Re: Sand Hill Estates #7 Preliminary Major Plat – Notice of Incomplete

Re: Sand Hill Estates #7 Preliminary Major Plat – Notice of Completeness

SAND HILL ESTATES VII
PRELIMINARY INFRASTRUCTURE PLANS
CITY OF OTHELLO, WASHINGTON

**HOOD STREET
PLAN & PROFILE**

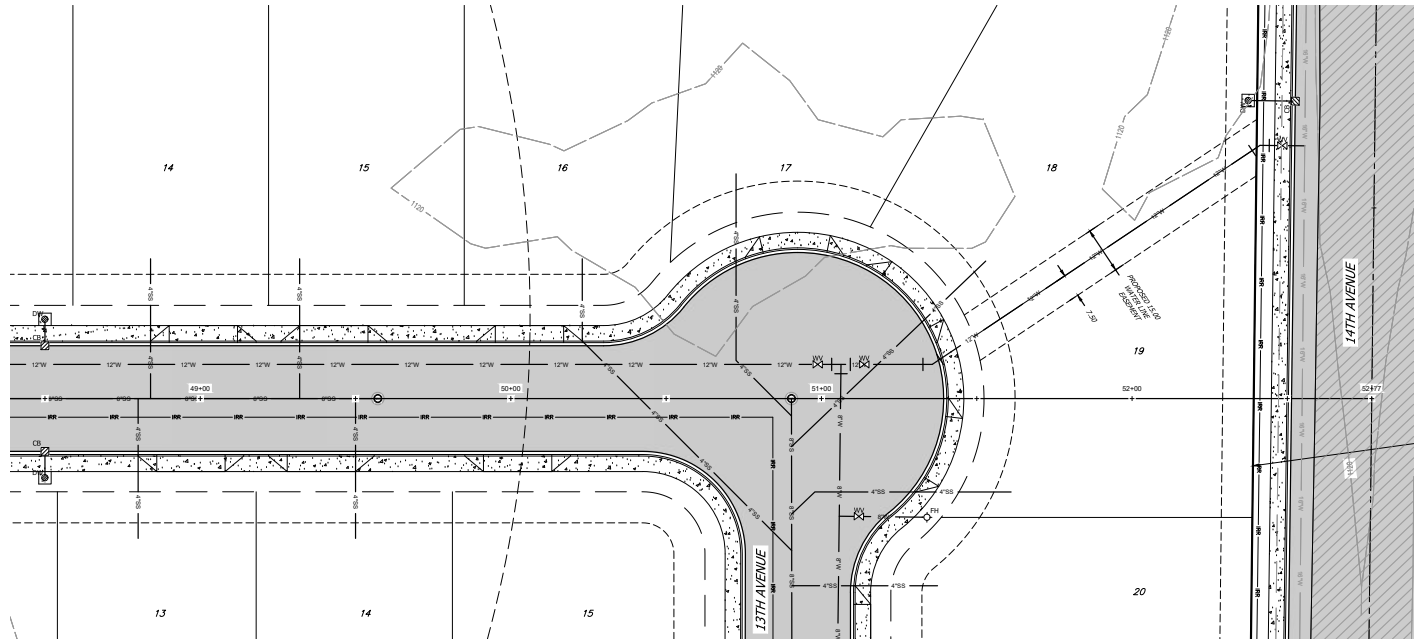
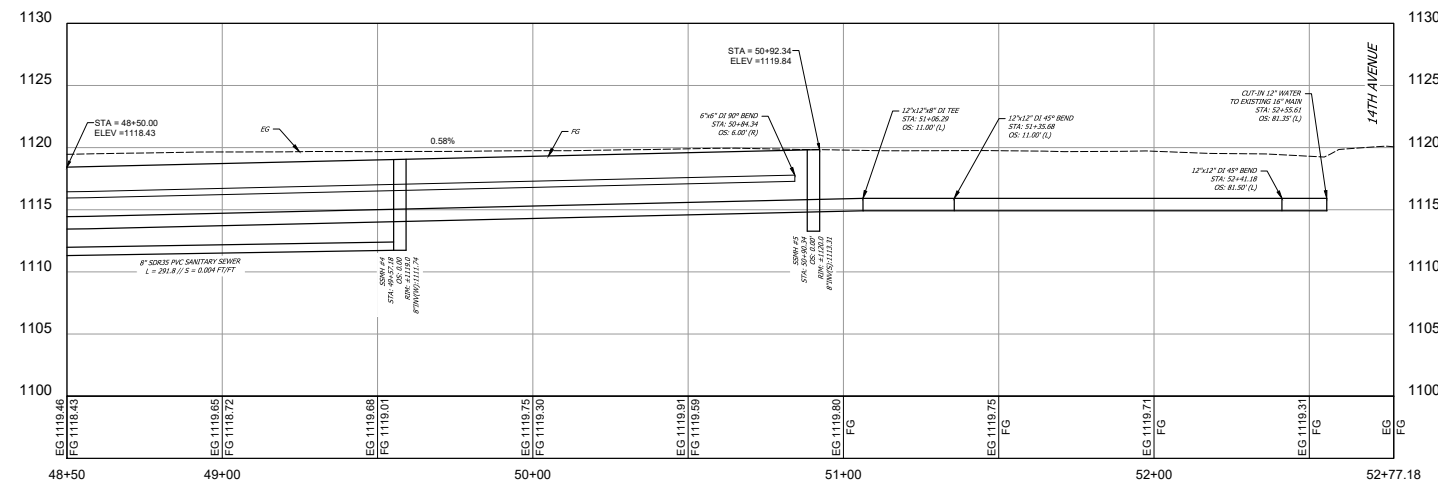
7. The plat drawing does not show a street name for the new street. Is it proposed as Hood Street, as shown on the construction plans?
